**Re: Nogales Transmission, L.L.C. – Nogales Interconnection Project – PP 420  
Application Amendment**

This letter amends the April 8, 2016, Application for a Presidential Permit for the Nogales Interconnection Project (the “Project”).

**I. OVERVIEW**

### **Project Configuration Diagrams**

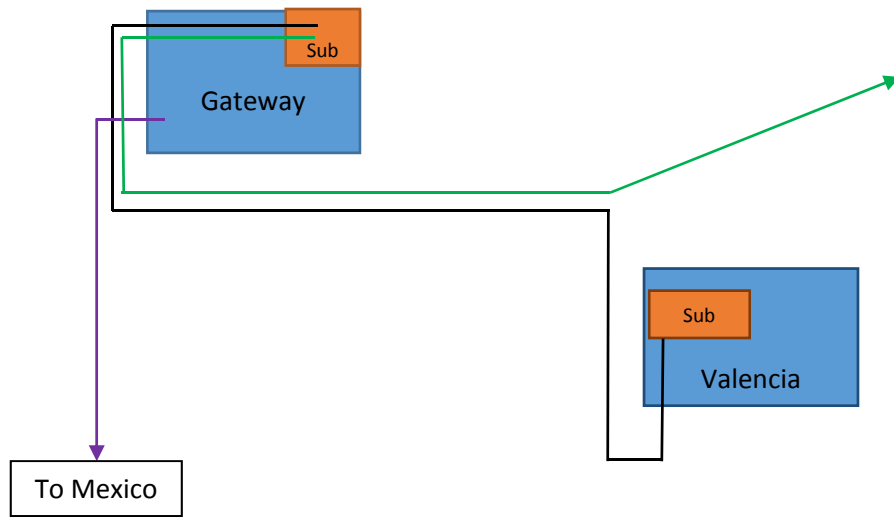
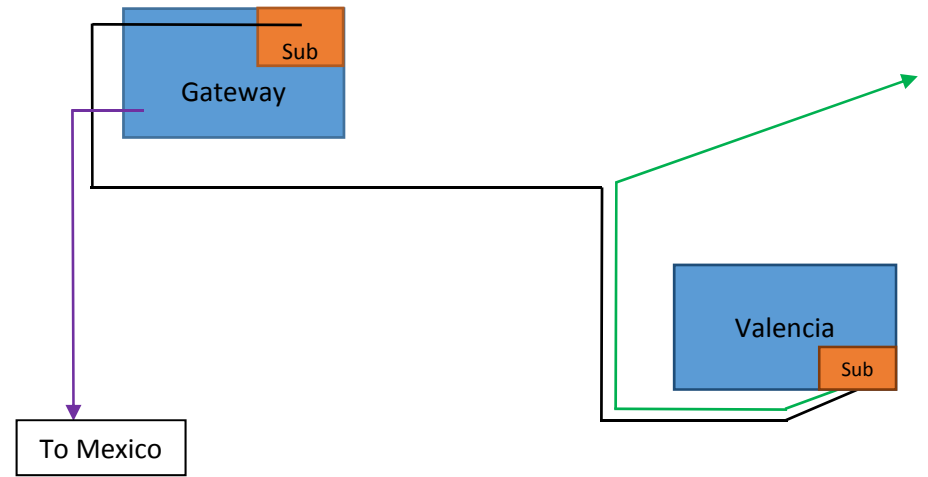
This amendment reflects an electrical reconfiguration that has been designed to make the Project more cost-effective. Conceptually, the new configuration connects the Project to the UNS Electric (“UNSE”) system at the planned Gateway Substation (“Gateway”) rather than, as originally proposed, at the existing Valencia Substation (“Valencia”). As discussed in more detail below, that connection will be accomplished by severing the existing UNSE Vail to Valencia 138-kV line and connecting it to one circuit of a new double-circuit 138-kV line, to be constructed and owned by UNSE, with an origination point near Valencia and a termination point at Gateway. A second circuit on that line will originate at Gateway and terminate at an existing UNSE line near Valencia; that circuit will serve as the source for Valencia. These changes are illustrated conceptually on Attachment 1, and the specific changes are detailed below. The reconfiguration does not change the proposed Project route or right-of-way requirements set forth in the Application, and as compared to the original configuration would have equal or better reliability.

The reconfiguration would connect the Project to the UNSE transmission system at Gateway rather than at Valencia. A new, approximately 3-mile long, overhead double-circuit 138-kilovolt (kV) alternating current (AC) transmission line would be constructed on new double-circuit monopoles. The first circuit will originate at an existing pole 1,900 feet west of the existing Valencia Substation and terminate at the new Gateway Substation. At the origination point, the existing Vail to Valencia line will be severed and connected to this new line, thereby converting the existing Vail to Valencia transmission line to the “Vail to Gateway” transmission line. The second circuit will originate at the Gateway Substation and proceed in an easterly direction to a pole 1,900 feet west of the existing Valencia Substation, where it will connect with the existing portion of the UNSE 138-kV transmission line that travels east along the north side of W. White Park Drive to the Valencia Substation. This circuit will constitute the new “Gateway to Valencia” transmission line. The reconfiguration is shown on a map at Attachment 2, and a one-line diagram of the reconfiguration is provided at Attachment 3.

**Project One-Line Diagram**

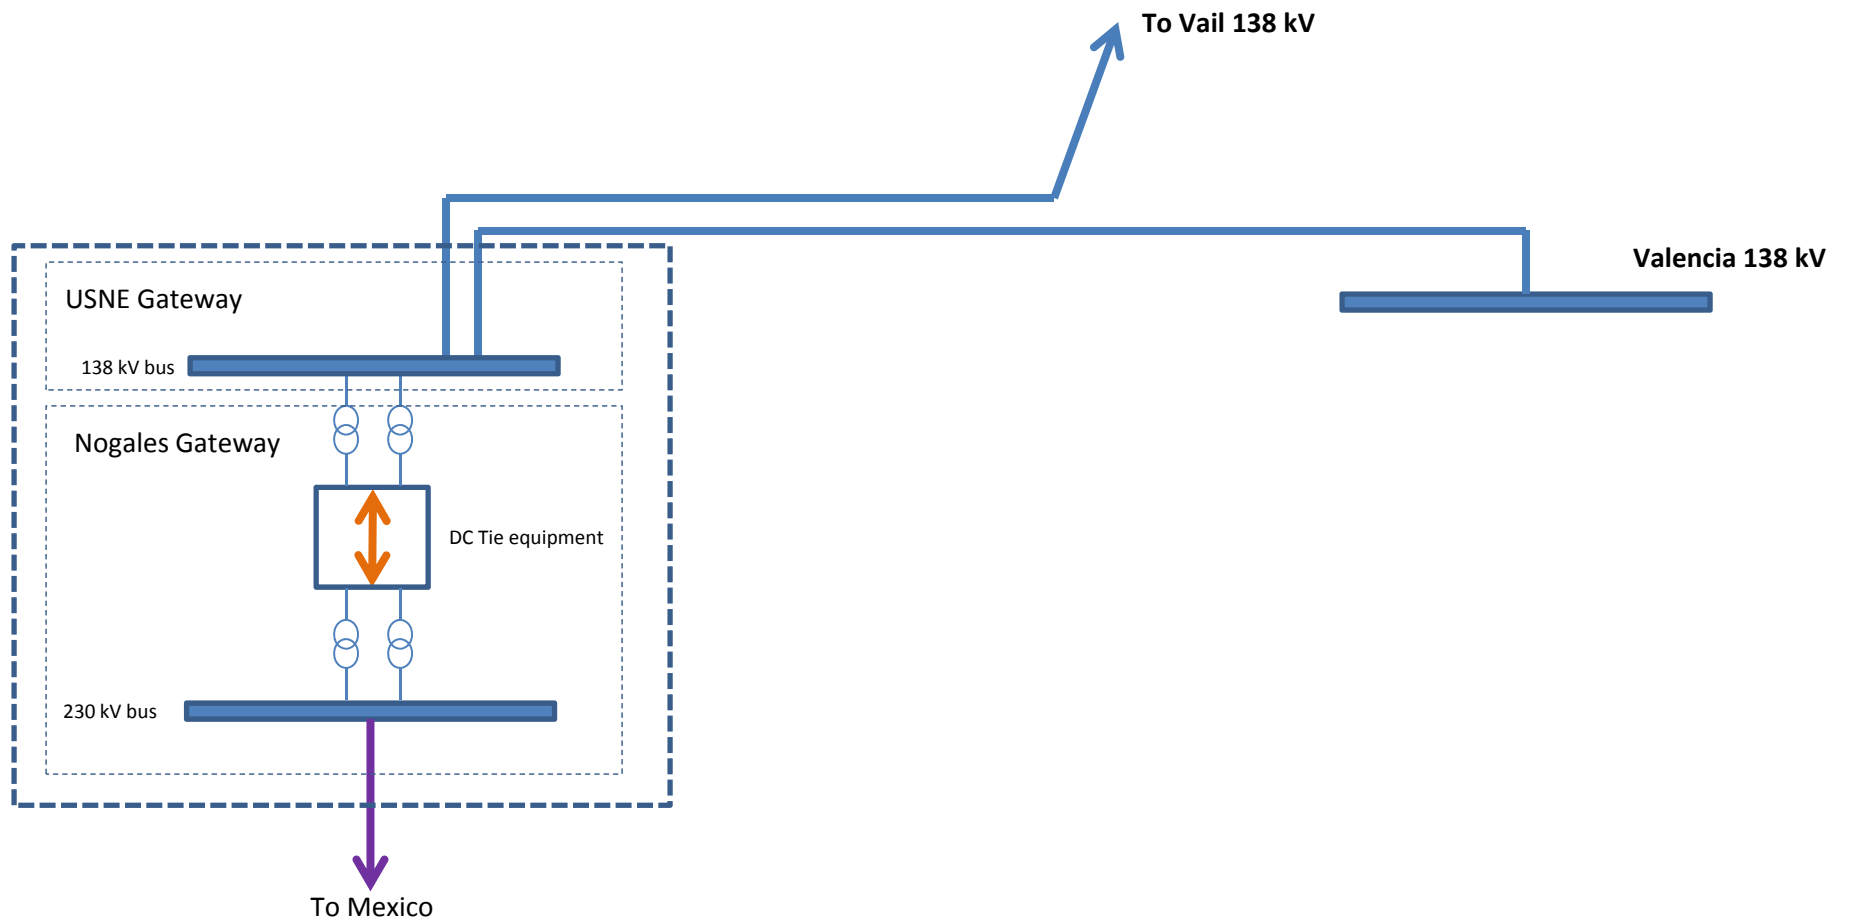
Under the new configuration, there will be only minor modifications relating to relaying equipment at the existing UNSE Valencia Substation; those modifications are necessary to accommodate the connection from the proposed 138-kV transmission line from Gateway to Valencia. Because the UNSE transmission line will now terminate at Gateway, in addition to the Gateway Substation envisioned in the original Application, a new approximately 1.8-acre UNSE 138-kV Gateway Substation will be constructed on the eastern edge of the Gateway site. This substation will consist of a three-bay, breaker and a half, open-air configuration that will accommodate the line from Vail, the line to Valencia, the connection to the DC converter and a future UNSE distribution transformer.

# Alternative 1 – Original vs Alternate Configuration

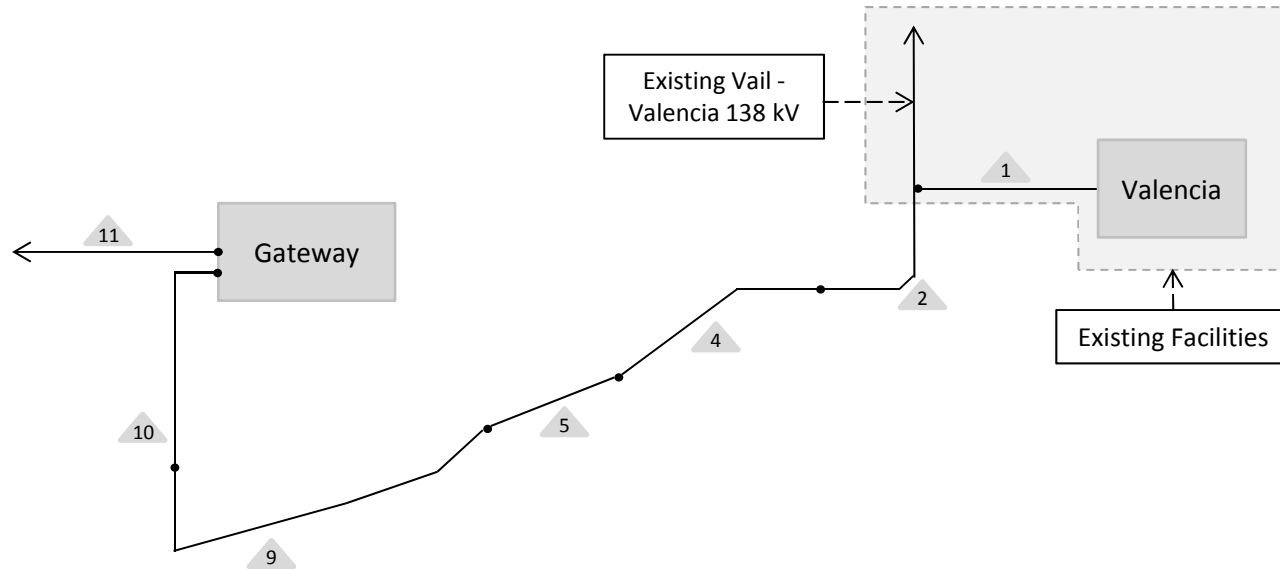
Segment	Original Configuration	Alternate Configuration
Valencia	Rebuild required	No rebuild required
1	Double-circuit 138kV on existing double-circuit poles	Single-circuit 138kV on existing double-circuit poles
2/4/5/9/10	Single-circuit 138kV on double-circuit poles	Double-circuit 138kV on double-circuit poles. Adding a second circuit does not impact pole height.
11/13/15	Single-circuit 230kV on double-circuit poles	No change
Gateway	Expansion and buildout	Same, with incremental 138kV facilities
ROW Width	150'	No change
ROW length	Approximately 5.8 miles	No change
Access Roads	3.08 miles of Access Type A and 0.24 mile of Access Type B, and require the upgrade of 3.22 miles of Access Type C roads. Additionally, 2.27 miles of Access Type D and 0.49 mile of Access Type E roads would be constructed.	No change

# Alternative 2 – Original vs Alternate Configuration

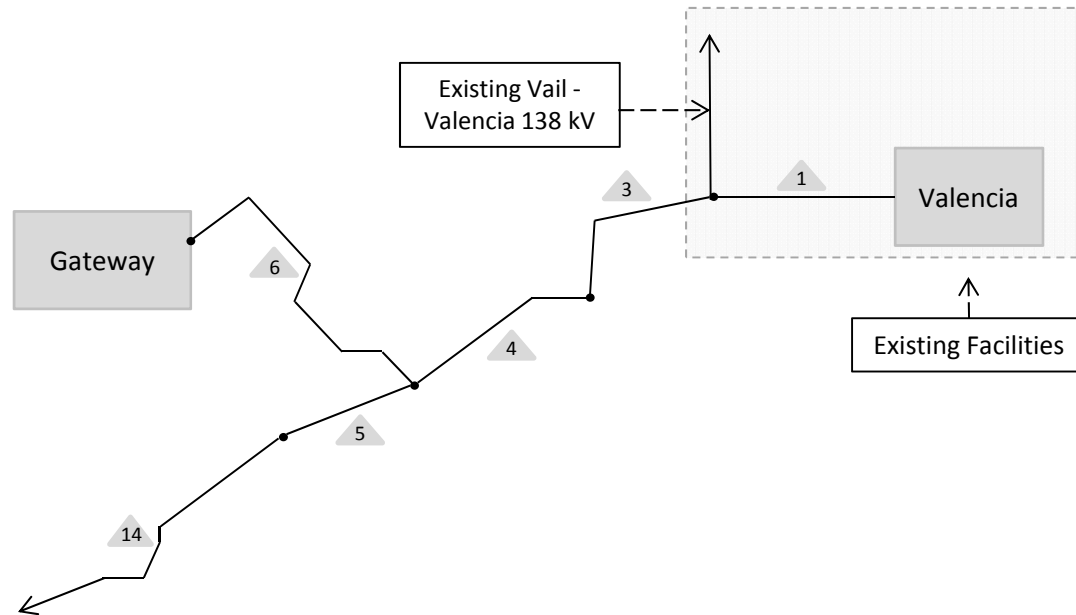
Segment	Original Configuration	Alternative Configuration
Valencia	Rebuild required	No rebuild required
1	Double-circuit 138kV on existing double-circuit poles	Single-circuit 138kV on existing double-circuit poles
3/4	Single-circuit 138kV on double-circuit poles	Double-circuit 138kV on double-circuit poles. Adding a second circuit does not impact pole height.
6	One circuit 230kV, one circuit 138kV on double-circuit poles; Seven poles with an average height of ~115 feet.	One circuit 230kV, two circuits 138kV on triple-circuit capable poles; Seven poles with an average height of ~140 feet.
5/14/15	Single-circuit 230kV on double-circuit poles	No change
Gateway	Expansion and buildout	Same, with incremental 138kV facilities
ROW Width	150'	No change
ROW length	Approximately 4.9 miles	No change
Access Roads	1.57 miles of Access Type A and 0.86 miles of Access Type B, and require the upgrade of 1.60 miles of Access Type C roads. Additionally, 2.00 miles of Access Type D and 0.38 mile of Access Type E roads would be constructed.	No change

# Alternative 3 – Original vs Alternate Configuration

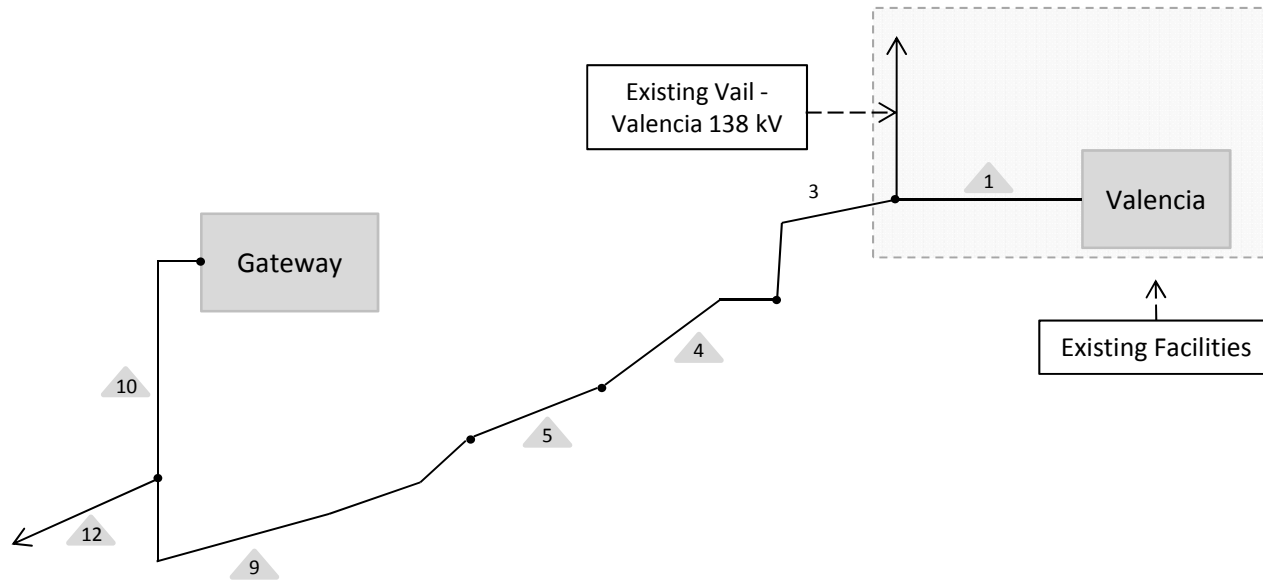
Segment	Original Configuration	Alternative Configuration
Valencia	Rebuild required	No rebuild required
1	Double-circuit 138kV on existing double-circuit poles	Single-circuit 138kV on existing double-circuit poles
3/4/5/9	Single-circuit 138kV on double-circuit poles	Double-circuit 138kV on double-circuit poles. Adding a second circuit does not impact pole height.
10	One circuit 230kV, one circuit 138kV on double-circuit poles; Five poles with an average height of ~110 feet.	Single-circuit 230kV on double-circuit poles, double-circuit 138kV on double-circuit poles; Twelve poles with an average height of ~100 feet.
12/13/15	Single-circuit 230kV on double-circuit poles	No change
Gateway	Expansion and buildout	Same, with incremental 138kV facilities
ROW Width	150'	No change
ROW length	Approximately 5.1 miles	No change
Access Roads	2.23 miles of Access Type A and 0.76 miles of Access Type B, and require the upgrade of 2.60 miles of Access Type C roads. Additionally, 1.97 miles of Access Type D and 0.26 mile of Access Type E roads would be constructed.	Same, with incremental 0.3 miles of Type E roads (spur roads).

# Alternative 4 – Original vs Alternate Configuration

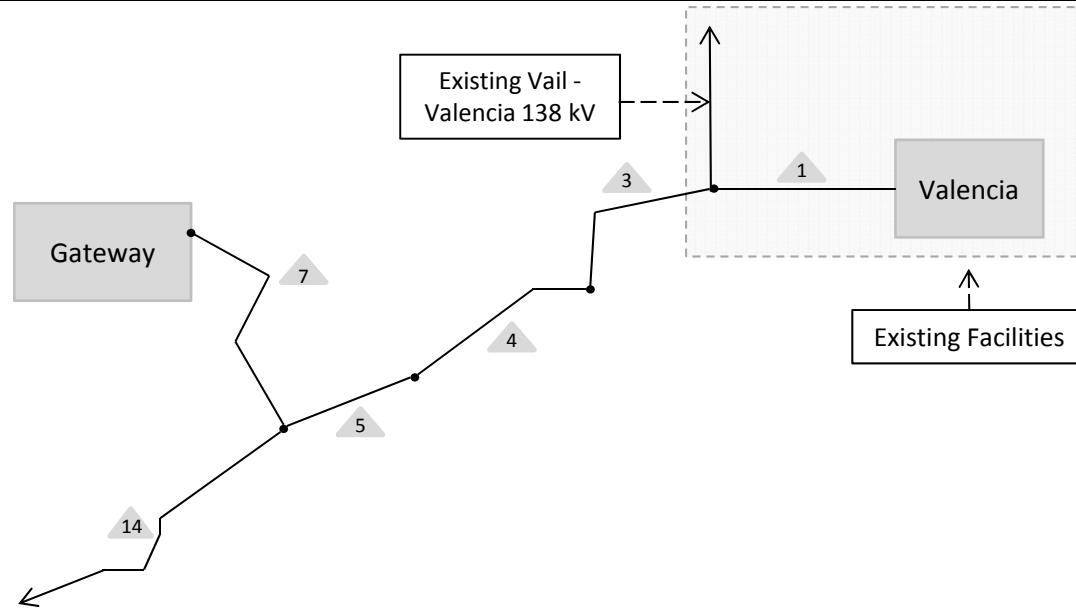
Segment	Original Configuration	Alternative Configuration
Valencia	Rebuild required	No rebuild required
1	Double-circuit 138kV on existing double-circuit poles	Single-circuit 138kV on existing double-circuit poles
3/4/5	Single-circuit 138kV on double-circuit poles	Double-circuit 138kV on double-circuit poles. Adding a second circuit does not impact pole height.
7	One circuit 230kV, one circuit 138kV on double-circuit poles; Five poles with an average height of ~115 feet.	Double-circuit 138kV line on double-circuit poles on one side of Mariposa Ranch Road and one 230 kV circuit line on double-circuit capable structures on the opposite side of Mariposa Ranch Road. Ten poles with an average height of ~105 feet.
14/15	Single-circuit 230kV on double-circuit poles	No change
Gateway	Expansion and buildout	Same, with incremental 138kV facilities
ROW Width	150'	No change
ROW length	Approximately 4.6 miles	No change

Access Roads	1.60 miles of Access Type A and 1.15 miles of Access Type B, and require the upgrade of 1.26 miles of Access Type C roads. Additionally, 2.04 miles of Access Type D and 0.26 mile of Access Type E roads would be constructed.	Same, with incremental 0.4 miles of Type E roads (spur roads).

### **Typical Tower Arrangement Diagrams**

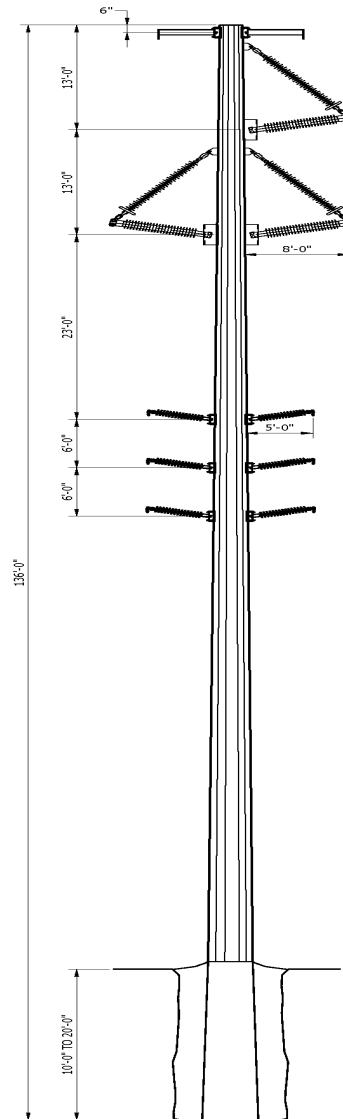
There would be changes to the tower configuration for route segments 6, 7 and 10. As noted above, route segment 6 would utilize a triple-circuit transmission line configuration, and route segments 7 and 10 would utilize double-circuit 138-kV transmission line and one 230-kV single-circuit on double-circuit capable structures in the same corridor. A conceptual arrangement for those tower configurations is provided at Attachment 5.

# Relevant for Alternative 2: Typical Arrangement of triple circuit capable poles within 150' ROW, Segment 6

# Relevant for Alternative 3: Typical Arrangement of 138 kV and 230 kV poles within 150' ROW, Segment 10
